# SERVICE *No.* 1023 BULLETIN

DATE: October 8, 1998 (S/M)

**Inspection of Landing Gear Cylinders and  
Distribution of Parker Hannifin Service  
Bulletin SB7063**

**Typical Landing Gear Cylinder  
Fig. 1**

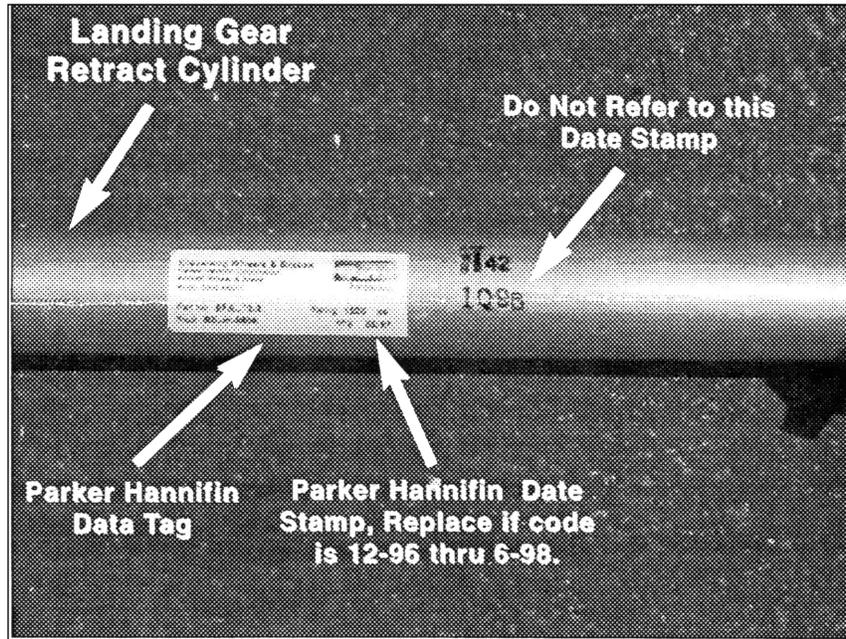
3. Gain access to the main and nose hydraulic landing gear cylinders and locate the data tag. A date of manufacture is stamped or printed on the tag. (See Fig. 1.)

4. Referring to the Parker Hannifin Service Bulletin for identification, the cylinders to be replaced will have date stamps **12-96** through **6-98**. Cylinders with date stamps before or after are not affected.

5. If removing any of the landing gear cylinders, refer to the appropriate Section or Chapter of the Maintenance Manual for detailed instruction on removing, replacing and rigging the landing gear.

6. Once the cylinders have been changed, fill and check the hydraulic fluid level and perform a complete gear cycle check per the appropriate Section or Chapter of the applicable Maintenance Manual.
